***New Circuit Switcher at Georgia Pacific Thorold Mill 121 kV SS
Notification of Conditional Approval of Connection Proposal
CAA ID Number: 2008-EX412***

ASSESSMENT SUMMARY

Georgia Pacific Thorold

Figure 1 - GP Thorold Mill 121 kV Substation – Future Configuration

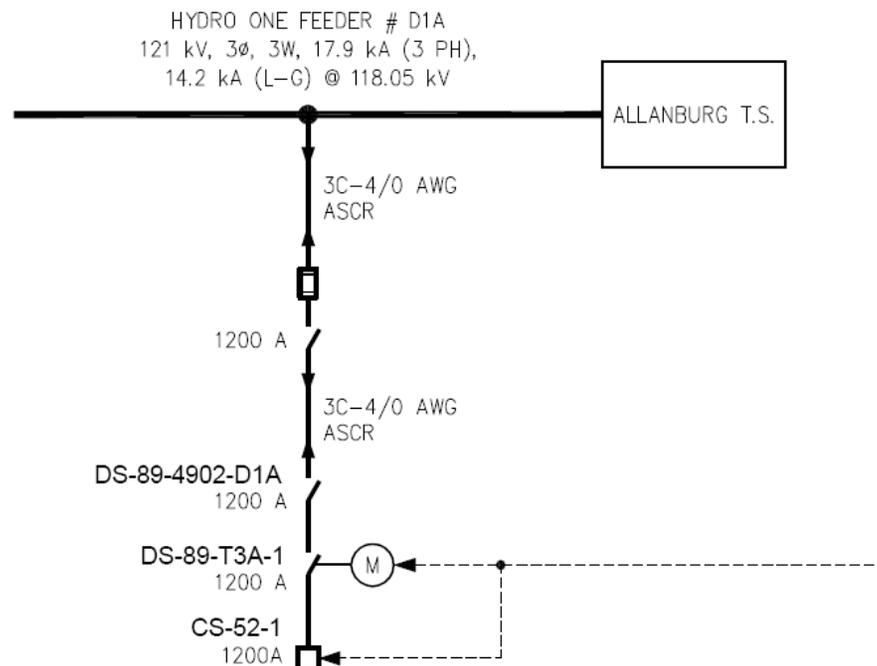
The new circuit switcher will meet the maximum voltage requirements stated in section 3.

The new circuit switcher does not meet the TSC requirements for short circuit capability. The installation of a circuit switcher with a 40 kA short circuit symmetrical duty rating instead of 50 kA rating is a risk assumed completely by Georgia Pacific Thorold. If any future system enhancements in the area result in short circuit levels higher than the capability of the new circuit switchers, Georgia Pacific Thorold is required to replace the new equipment with higher rated equipment at their expense.

Based on typical short time emergency ratings of the T3 transformer at GP Thorold Mill’s 121 kV substation, the continuous current rating of the new circuit switcher appears to be adequate.

- must have a maximum continuous voltage rating of at least 127 kV; and
- must remain in service and not automatically trip for voltages up to 5% above the maximum continuous voltage or 133.4 kV, for up to 30 minutes, to allow the system to be re-dispatched to return voltages to their normal range.

The TSC states in section 10.5.5 that “when circuit switchers are used, the interrupter and disconnect switch shall operate independently. Protection systems that trip the interrupter shall simultaneously initiate opening of the disconnect switch.”

The TSC also states in section 10.5.6 that “the direct current voltage supplied to the interrupter and disconnect switch shall be fed from separately fused and monitored direct current supplies: that is, by two direct current cables to the control cabinet.”
